WELL NO **MULE-31N Mule 31-13-2** API NO. **43-037-31618**

Ref: Sundry Notice: Mule 31-N Well
Change Location and Name

Due to the fact that the original location for vertical drilling of this well lay on an area that is use by the local community for ceremonial rituals, it has been necessary to move the surface location. The well will now have to be drilled **directionally**. Refer to attached revised details. In addition, the name of the well has been changed. Location/name details are as follows:

WELL LOCATION PLAT

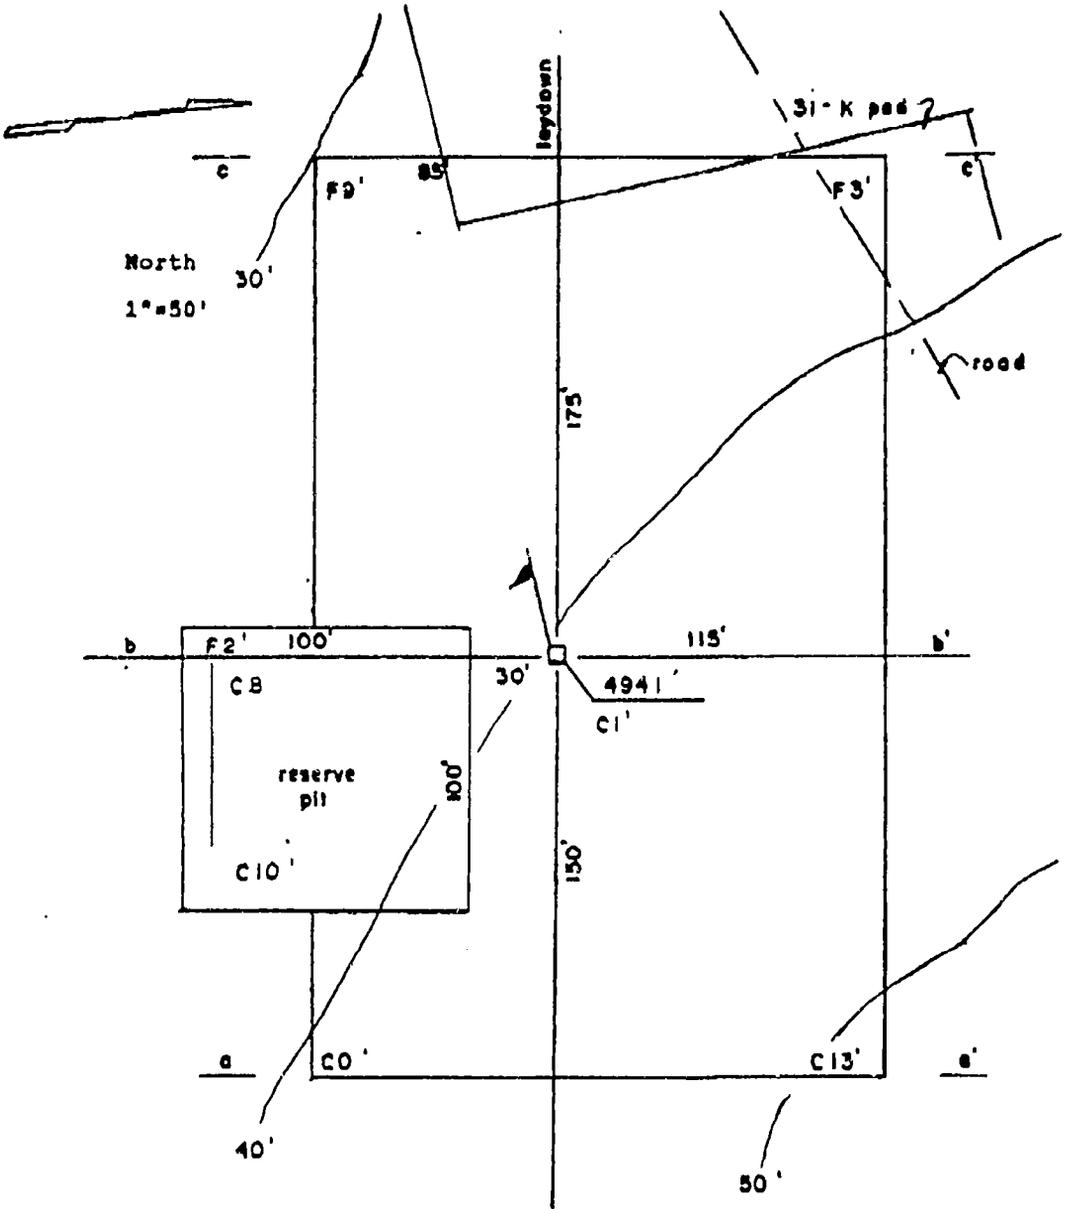
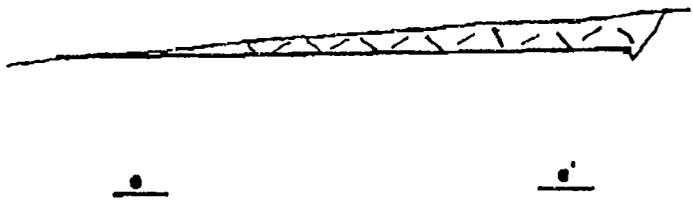
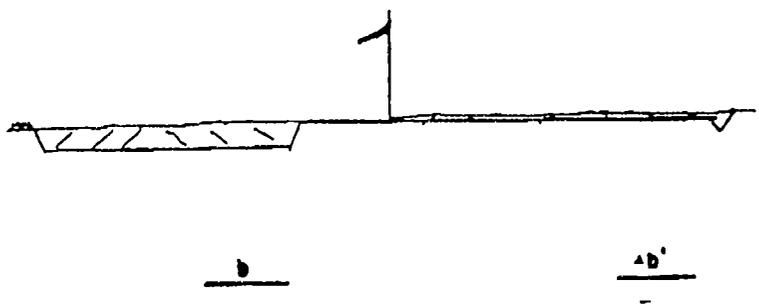
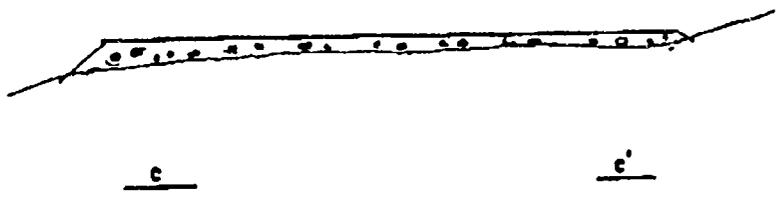
Old name: Mule 31-N
Old location: 740' FSL, 2585' FWL

New name: Mule 31-K-2
New location: 1450' FSL, 2230' FWL (Surface)
590' FSL, 2440' FWL (Subsurface)

CHUSKA ENERGY CO., Mule 31-K-2
 1450' FSL & 2230' FWL (top hole)
 590' FSL & 2440' FWL (bottom hole)
 Section 31, T.41 S., R.24 E., S1M
 San Juan County, UT
 4941' ground elevation

State plane coordinates from seismic control:
 X = 2,633,919 Y = 193,243 (top hole)
 X = 2,634,141 Y = 192,384 (bottom hole)
